HISTORIC AND DESIGN REVIEW COMMISSION

December 19, 2018

HDRC CASE NO: 2018-472
ADDRESS: 410 BARRERA
414 BARRERA
LEGAL DESCRIPTION: NCB 926 (EIM LAVACA), BLOCK 4 LOT 32
NCB 926 (EIM LAVACA), BLOCK 4 LOT 33
ZONING: IDZ, H
CITY COUNCIL DIST.: 1
DISTRICT: Lavaca Historic District
APPLICANT: Nate Manfred/French and Michigan
OWNER: EIM Partners
TYPE OF WORK: Construction of additions, exterior modifications, site work
APPLICATION RECEIVED: November 30, 2018
60-DAY REVIEW: January 29, 2019
REQUEST:

Additions and Remodels – 410 & 414 Barrera, San Antonio, Texas, 78210

410 & 414 BARRERA - LINE OF SIGHT
 SCALE: 1" = 20'-0"

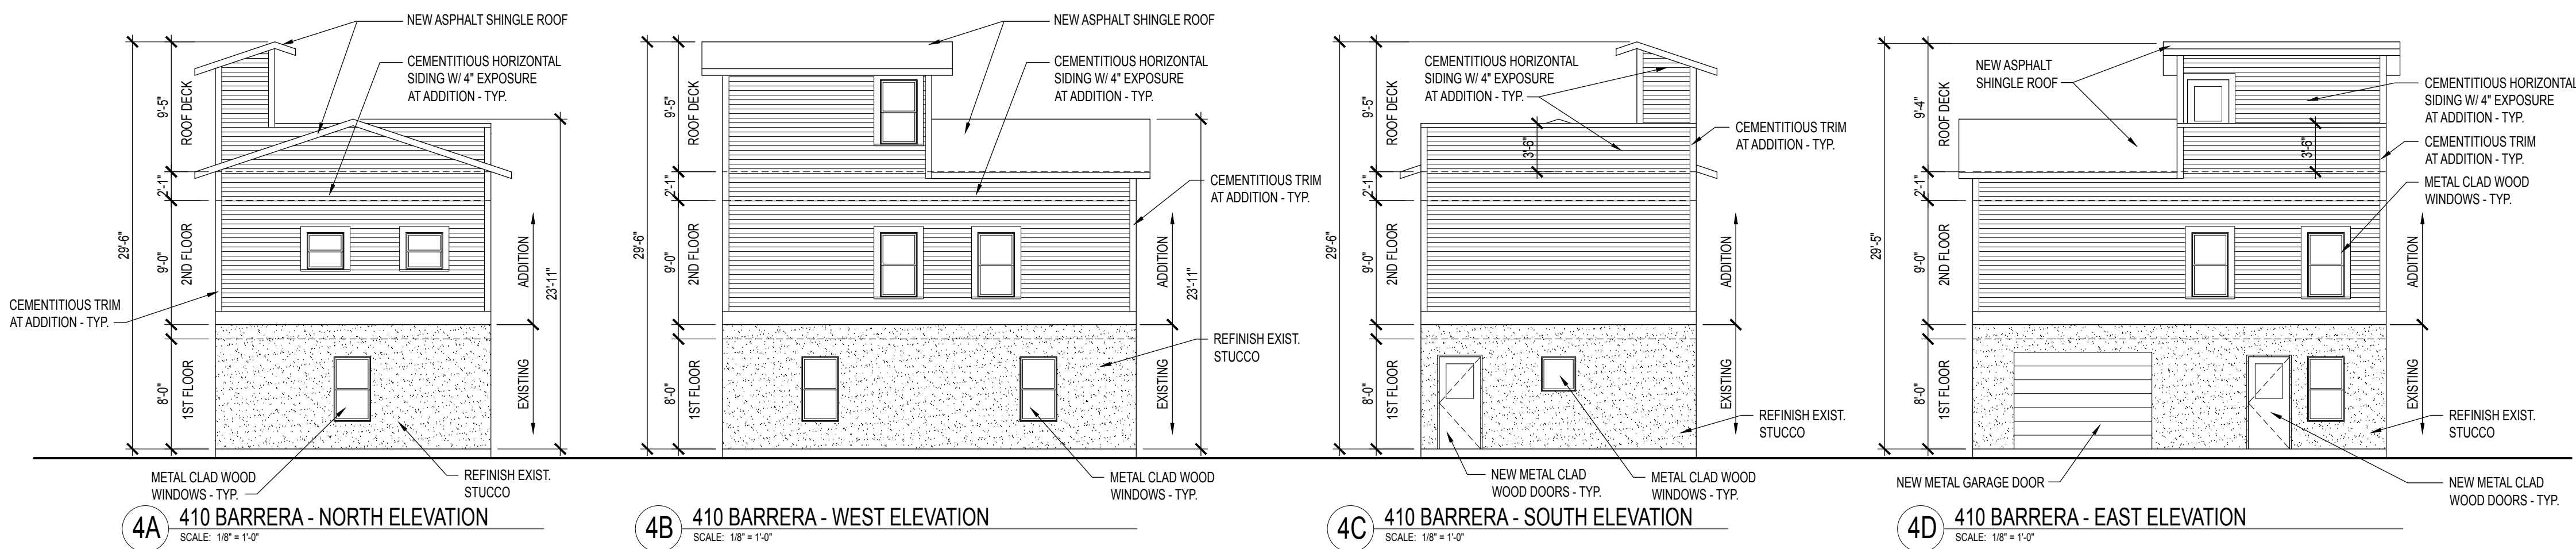
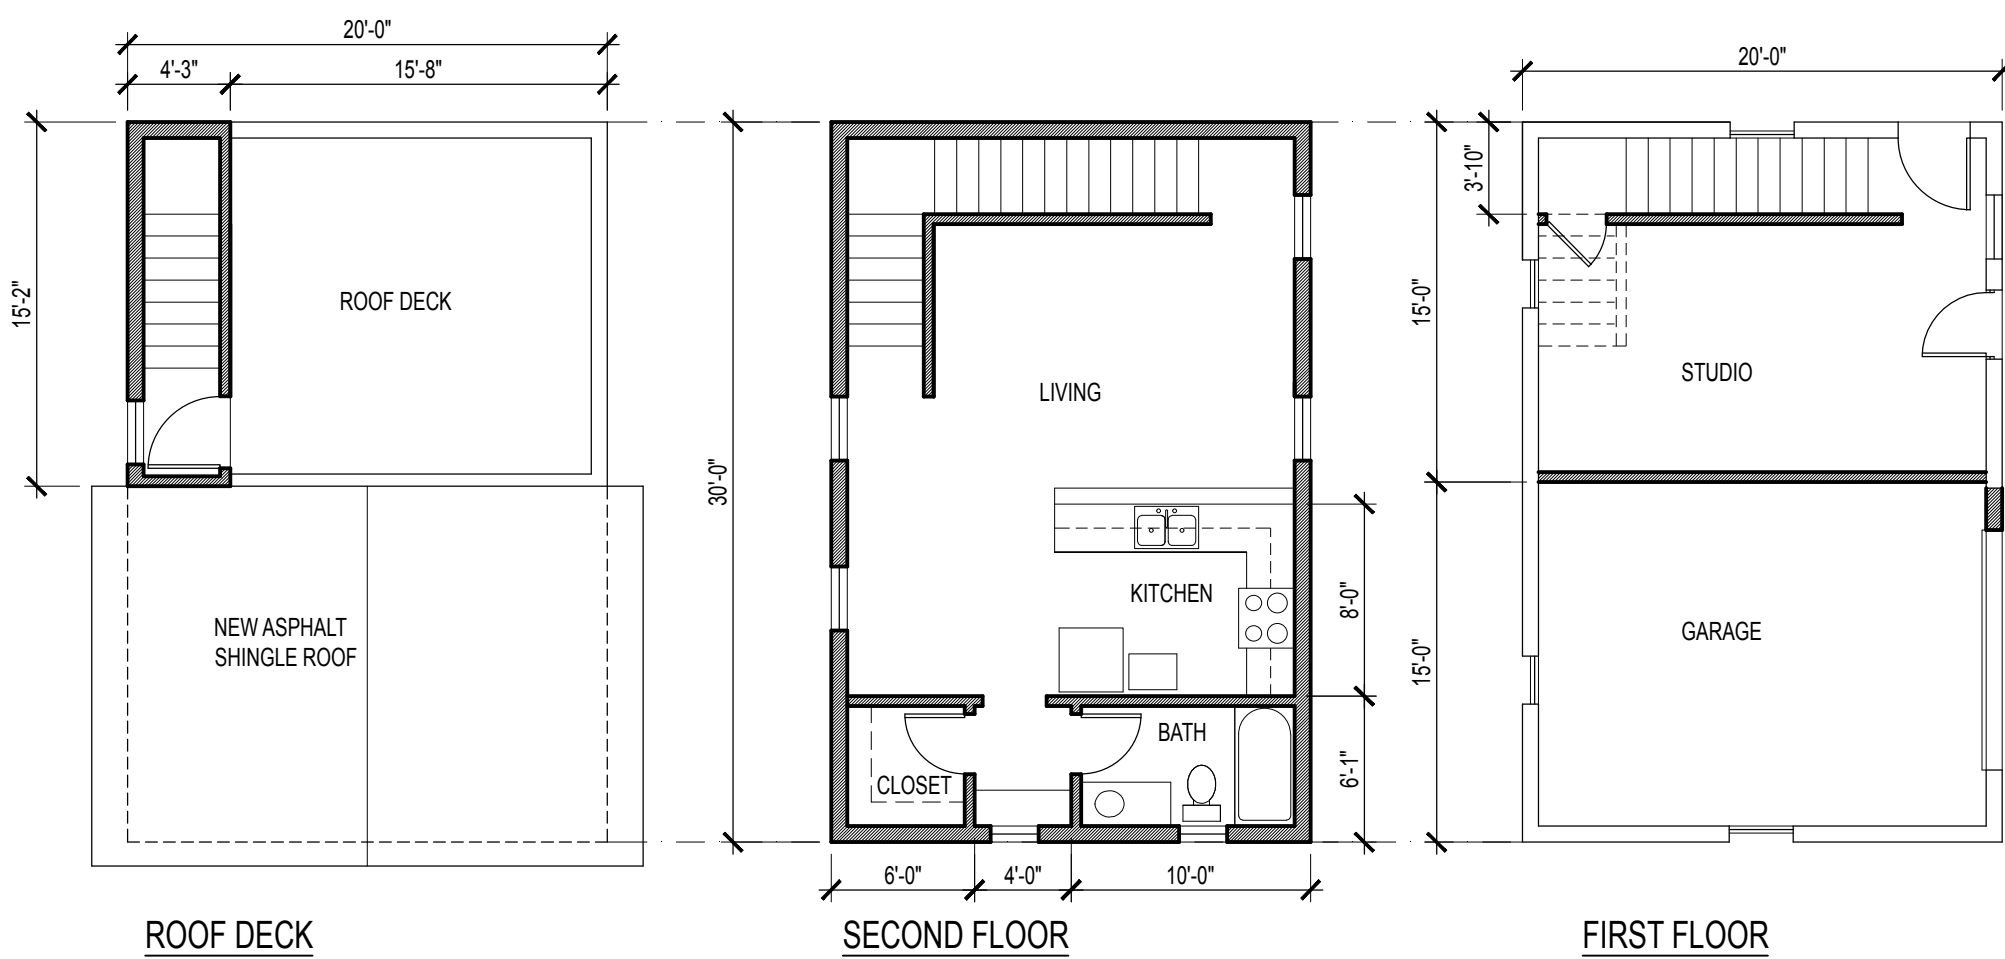
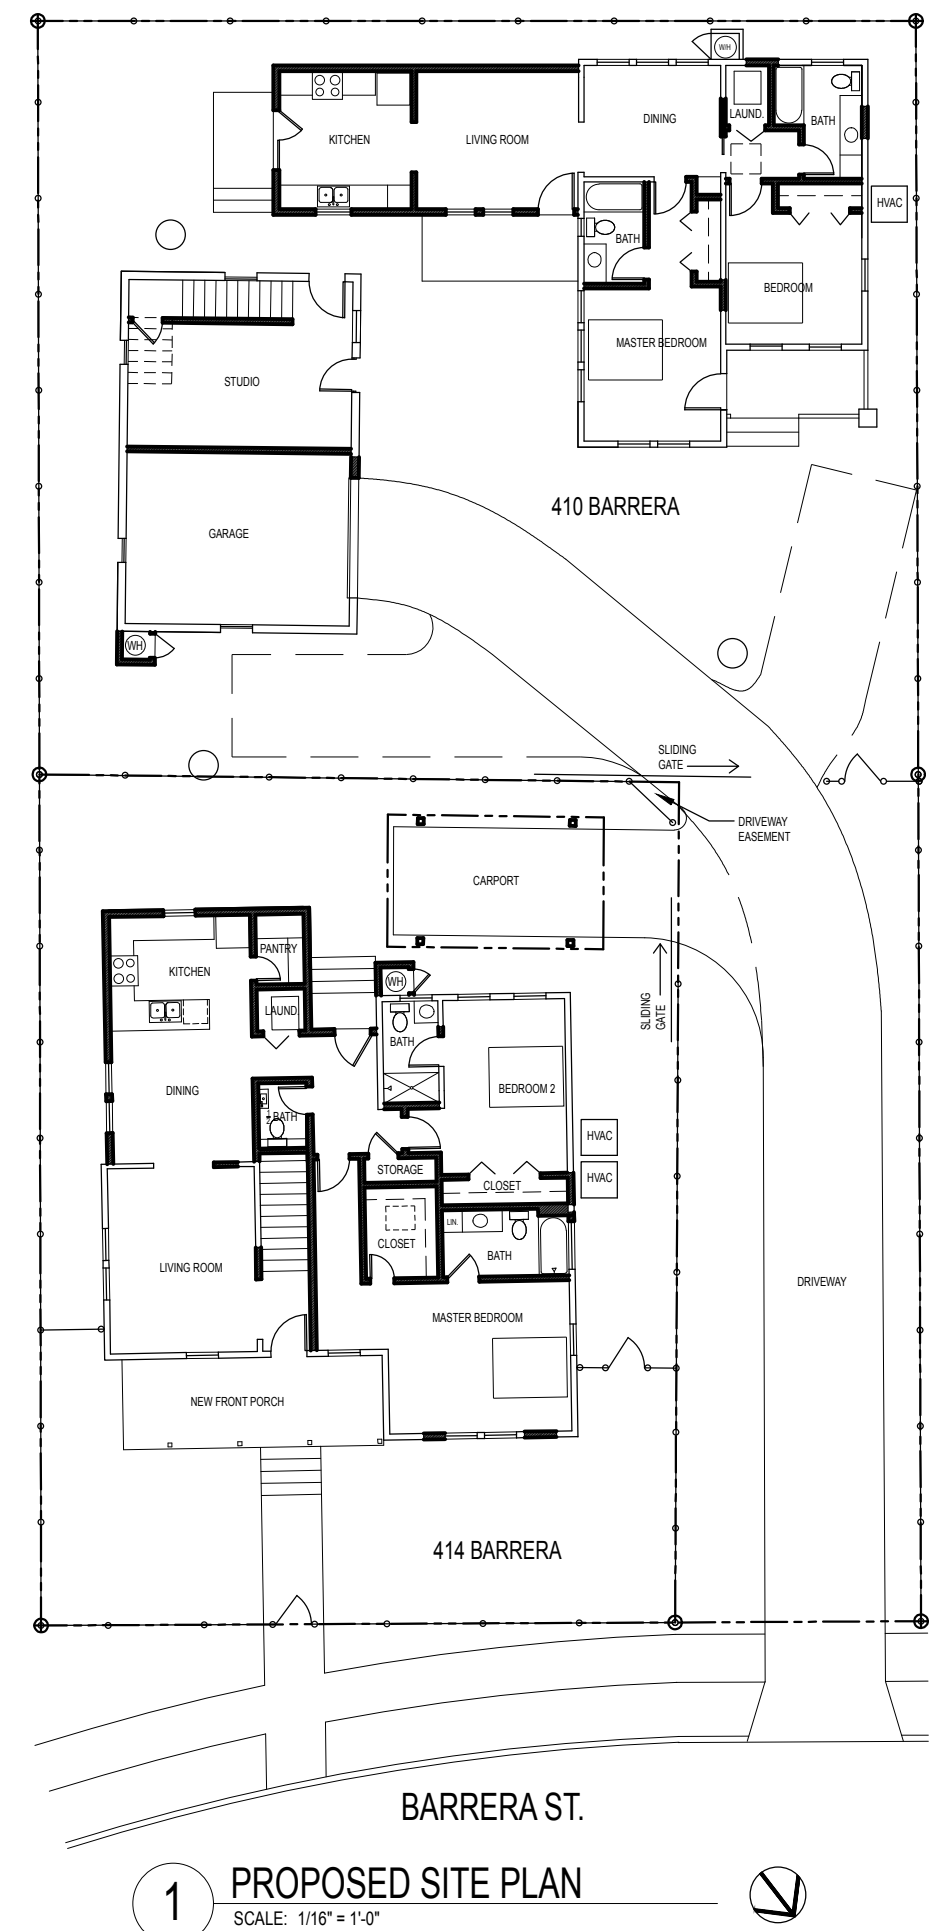
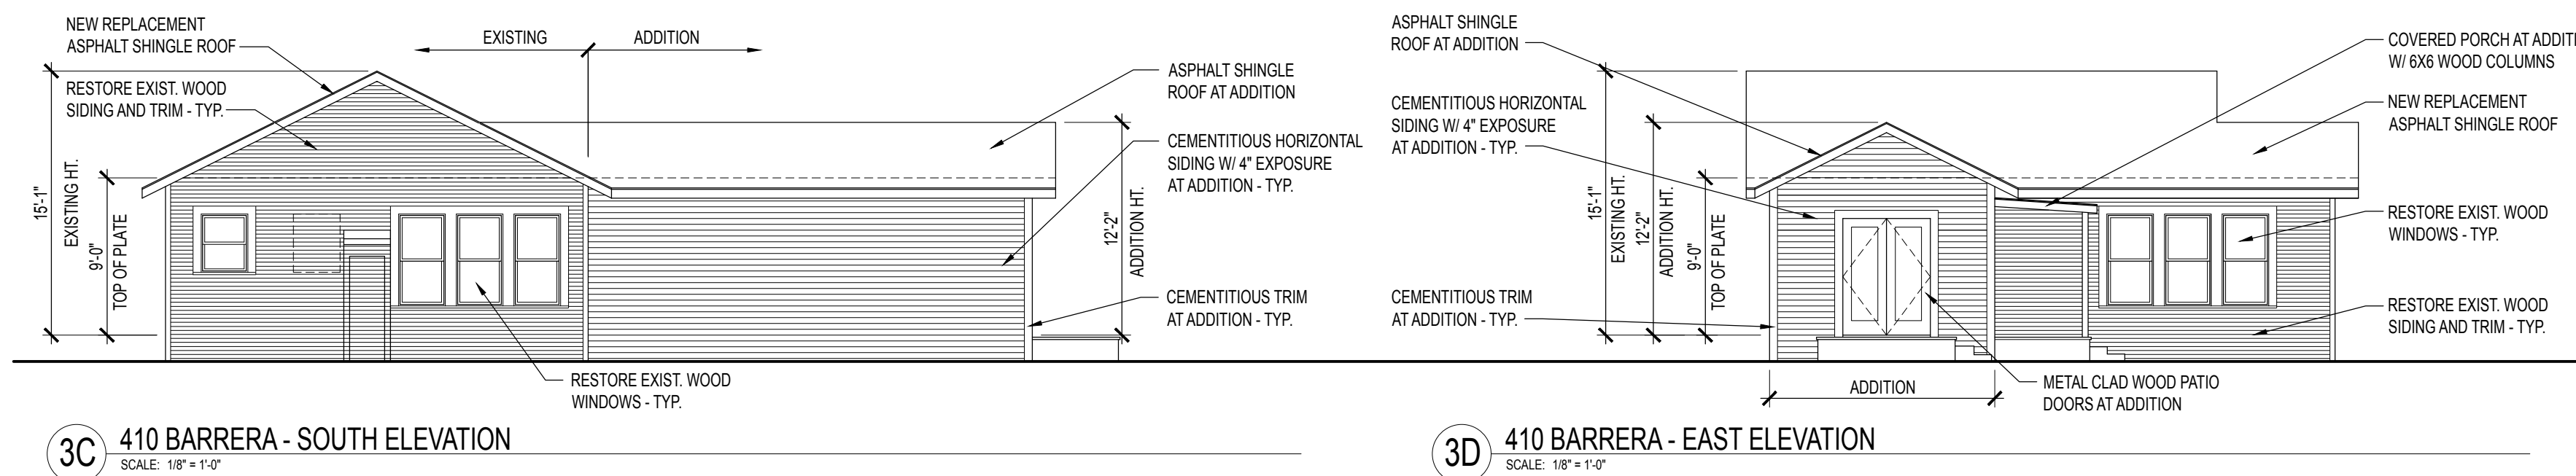
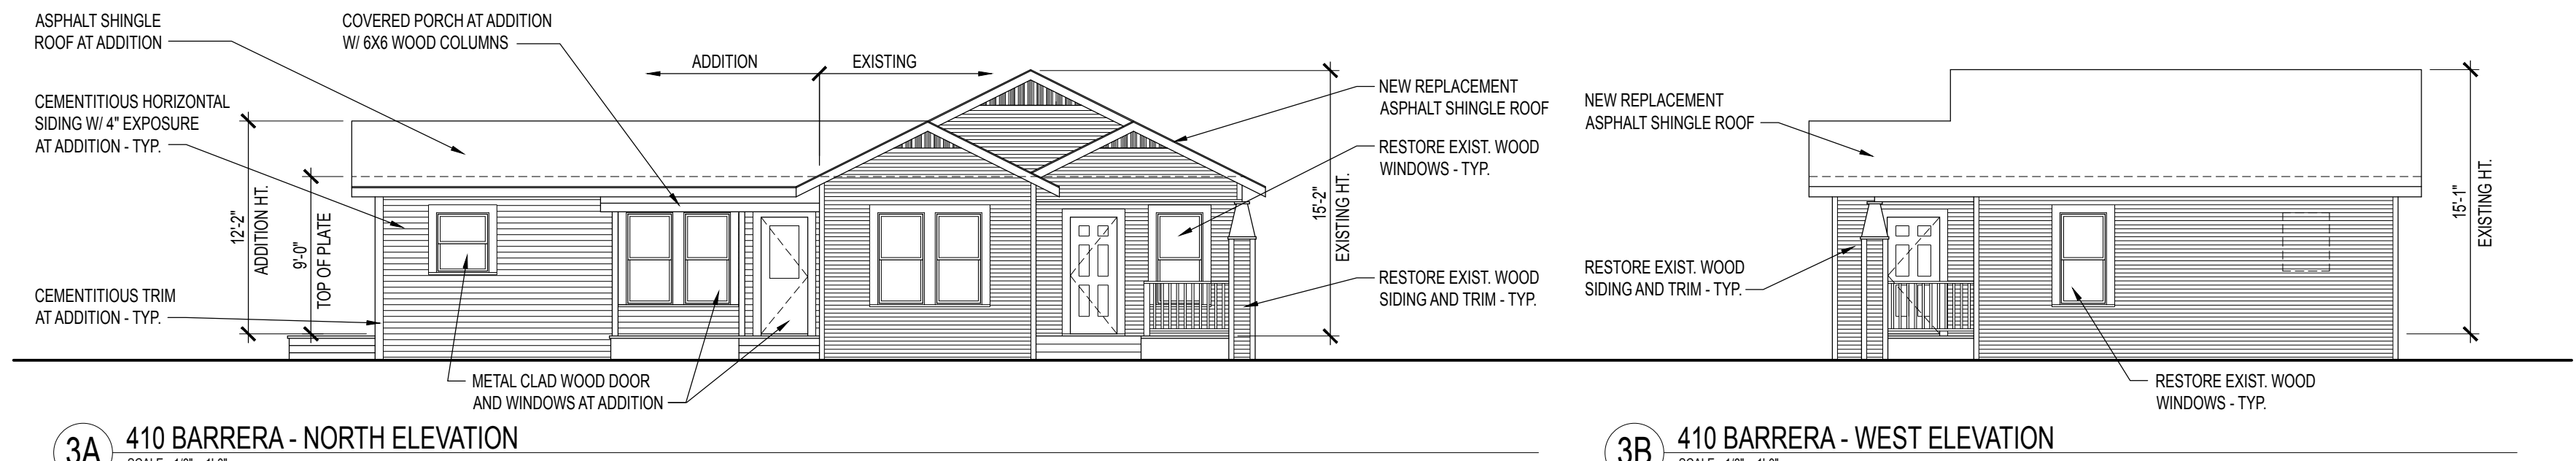
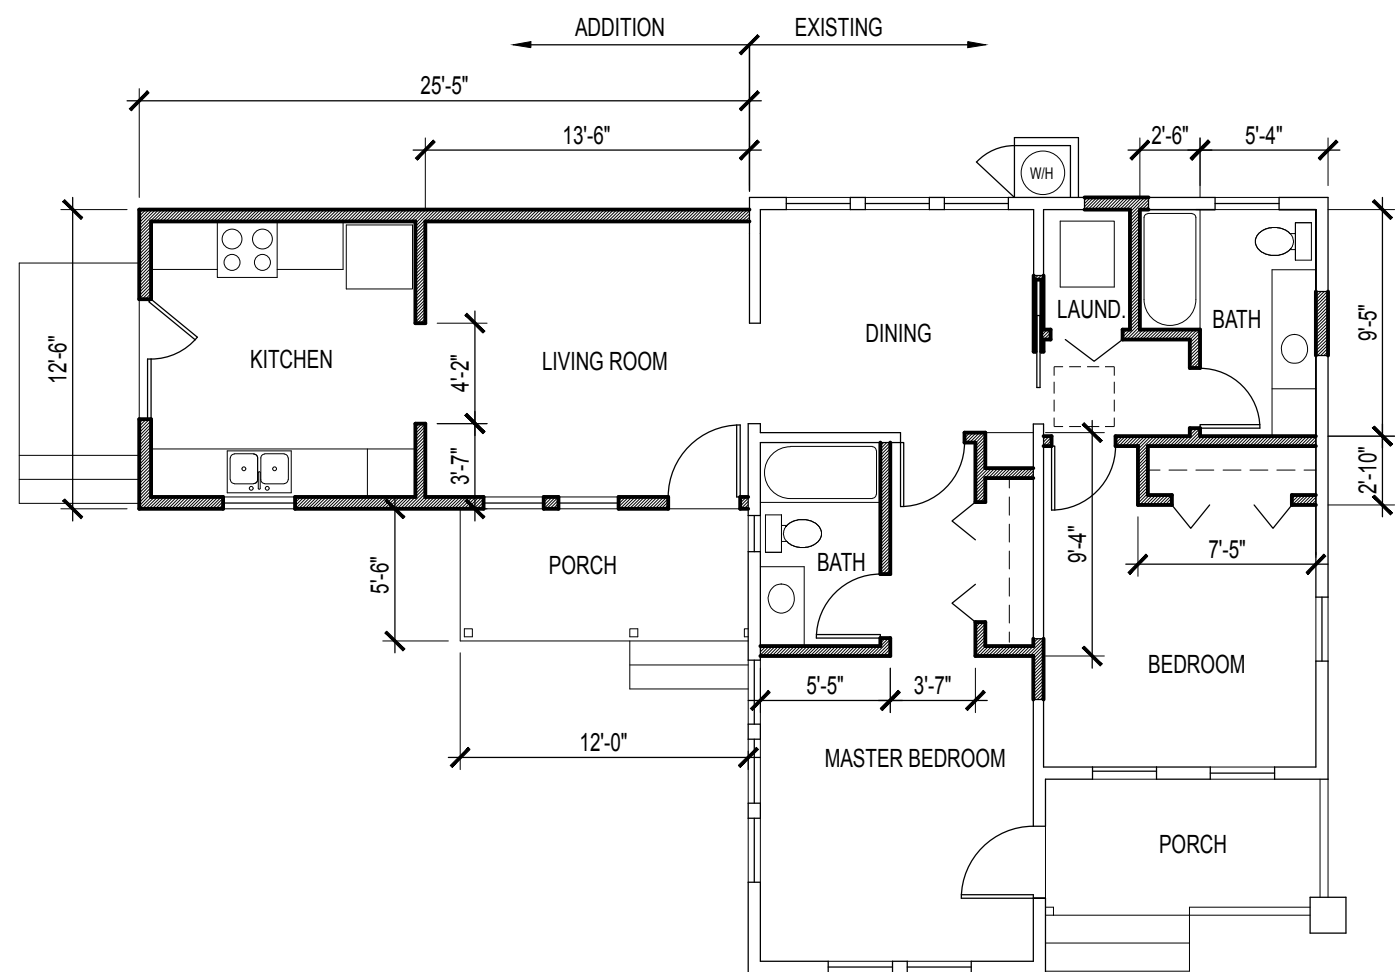
- 4e. SCALE, MASS & FORM – Regarding scale, mass and form, the applicant has proposed an addition that in footprint is appropriate. Staff finds that the applicant should provide a line of sight study from the right of way at Barrera to document the level of visibility of the proposed two story addition.
